**MAJOR PROJECT ASSESSMENT:  
Section 75W Modification  
*150 Epping Road, Lane Cove*  
*(MP10\_0148 MOD 1)***

Director-General's  
Environmental Assessment Report  
Section 75W of the  
*Environmental Planning and Assessment Act 1979*

November 2013

Figure 3: Site plan – Proposed modified building envelopes

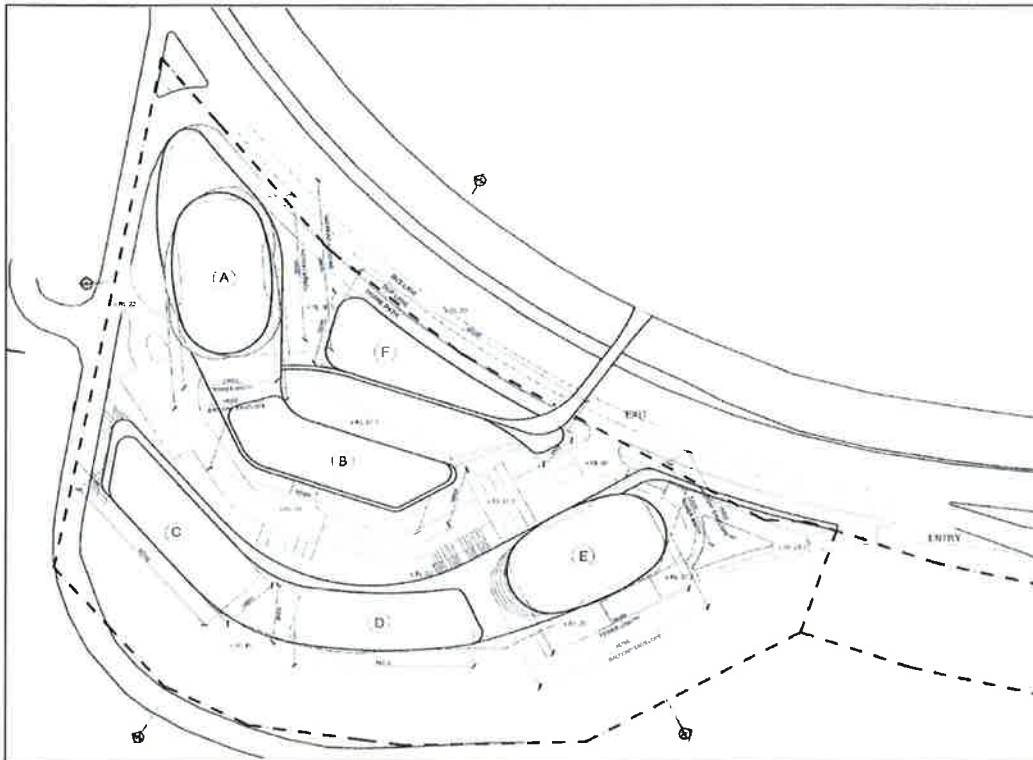
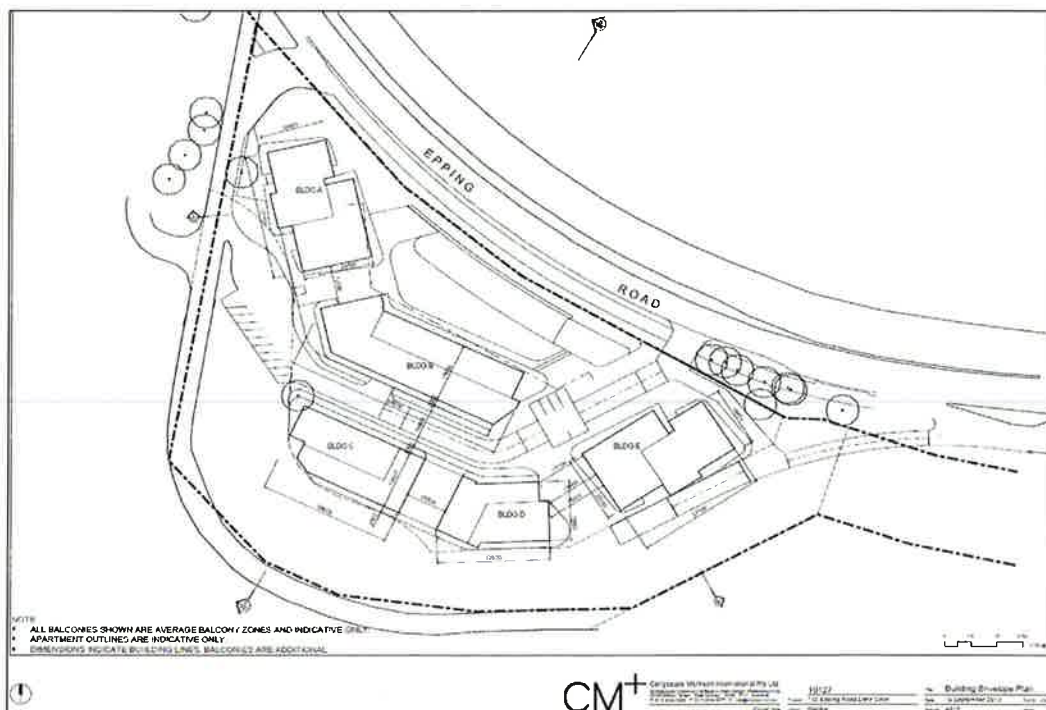
The proposed change to the approved building envelopes from elliptical to regular shapes and a reduction in floor to ceiling heights (from 3.2 m to 3.1 m) will essentially retain the development's relationship with neighbouring development and will not result in any measurable amenity impacts. Future DAs for buildings will have to demonstrate compliance with SEPP 65 criteria and achieve design excellence, in accordance with Future Assessment Requirement number 1 of the concept plan approval. The proposed changes to the envelopes and footprints are therefore supported.

**Figure 4: Proximity to Epping Road bus stops and existing pedestrian bridge (at Sam Johnson Way):**

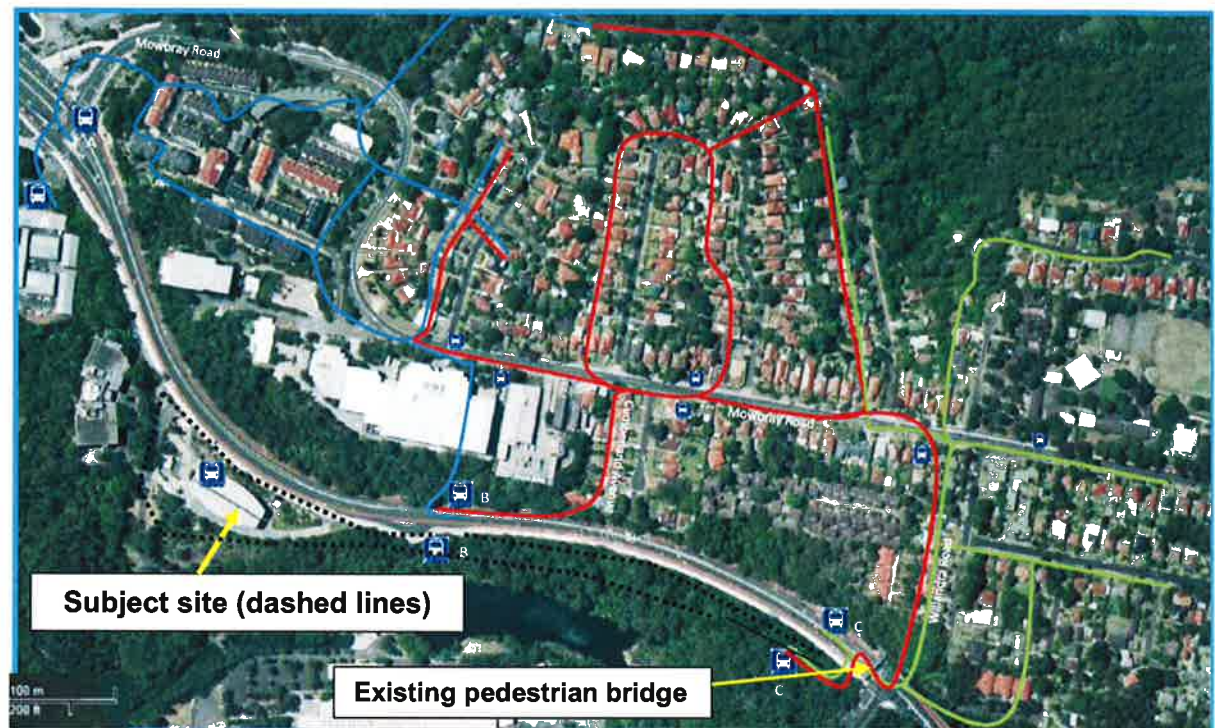
- a pedestrian bridge is fundamental to address the site's isolation;
- the bridge will provide an important community benefit for the site's future residents, providing a safe crossing to the bus stop on the eastern side of Epping Road; and
- there is a clear nexus between the proposed development and provision of access for future residents to city-bound bus services.

The Department considers that the commitment to provide a pedestrian bridge was not sufficiently justified with regard to its location, future ownership and maintenance responsibilities, impacts on adjacent bushland, and its proximity to an existing pedestrian bridge over Epping Road at Sam Johnson Way.

The Department considers that pedestrian access to and from the site is satisfactory and the existing pedestrian infrastructure in the vicinity of the site provides continuous, safe access to bus stops on both sides of Epping Road, as illustrated in Figure 4. The Department also considers that the walking distance to the traffic signals at the Epping Road / Mowbray Road intersection (300m) and the existing pedestrian bridge at Sam Johnson Way (590m) is reasonable to access city-bound bus services.

Accordingly, the department considers that and the deletion of the commitment to provide a pedestrian bridge is acceptable in the circumstances.

**Figure 4: Proposed exit-only “G” (red arrow) from the site adjacent to slip lane**

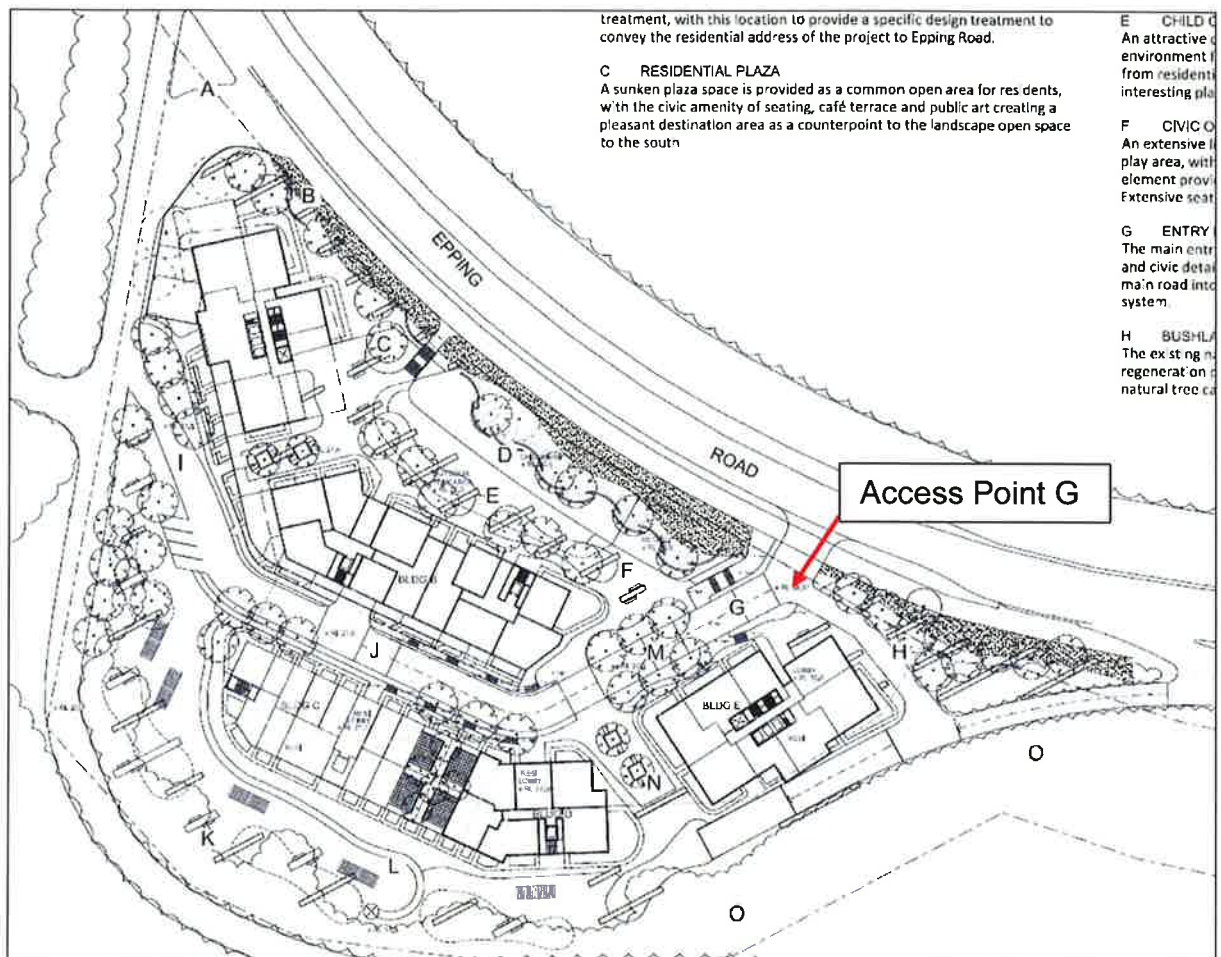
The proponent argues that a road safety audit is no longer required as the proposed modified access arrangements, including deletion of an on-site slip lane (see further details over) mean conflicts between traffic slowing down to enter the site's western end and traffic accelerating to exit via the eastern end will not occur.

The RMS did not object to the application (as amended in the PPR) as the change to the access point (denoted as "G" in **Figure 5** below) to an exit-only onto Epping Road will remove potential conflicts between vehicles entering and exiting the site. Accordingly, the

Department considers that this aspect of the application is reasonable and recommends it be approved.

**Figure 5: Location of site relative to Ingreion site and Lane Cove Tunnel western ventilation stack**

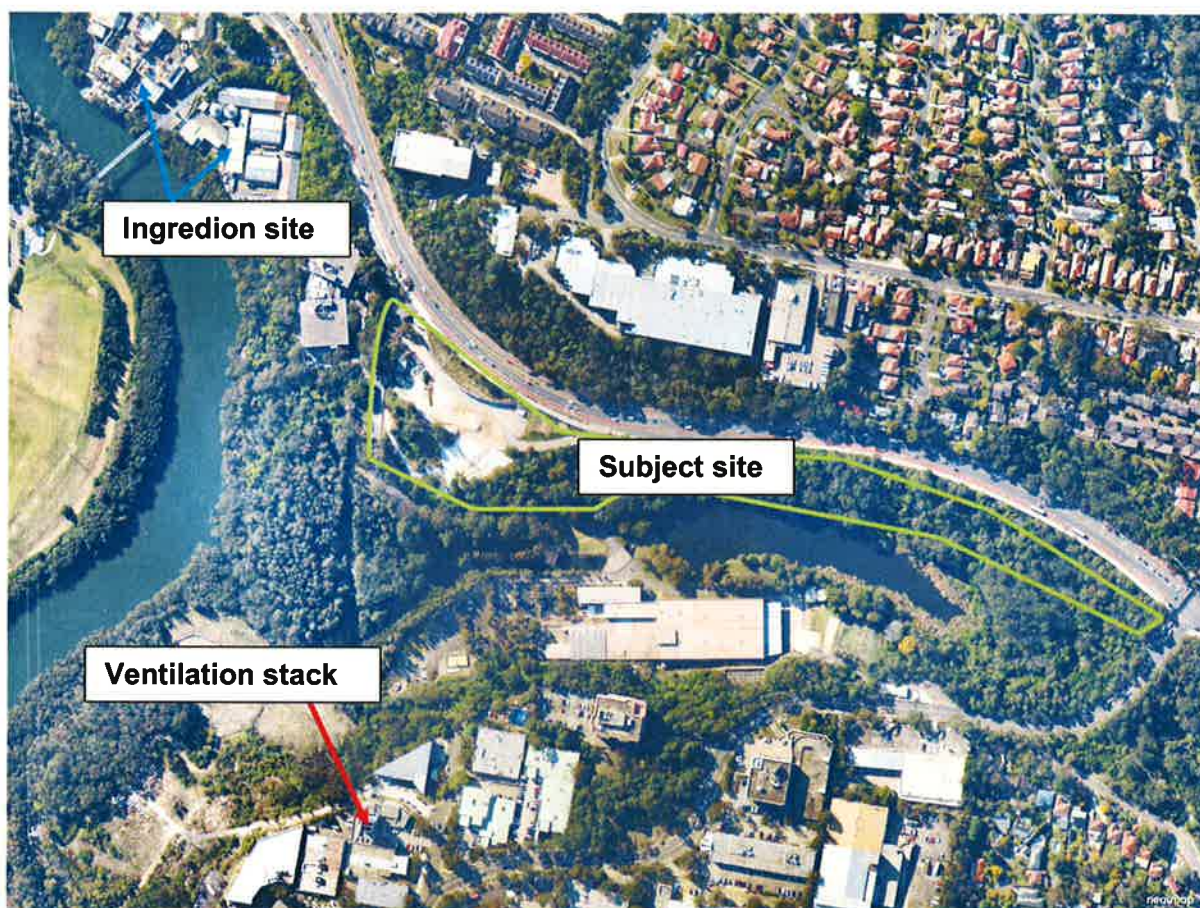
Ingreion (formerly National Starch Pty Ltd), the owner of 170 Epping Road (to the north-west of the site – see **Figure 5**), objected to the application on the grounds of potential conflicts with the proposed child care centre and its site operations in terms of odour and potential chemical hazards.

The Department considers there is sufficient separation distance from the location of the tunnel ventilation stack approximately 330 m to the south of the site (see **Figure 5**). The Department notes that the concept plan approval already requires the proponent to undertake a detailed air quality assessment (including odour) with the submission of future applications. The Department has revised the air quality assessment requirements (Future Assessment Requirement number 7) to include consideration of additional mitigation measures to minimise odour impacts in the detailed design stage of the development.
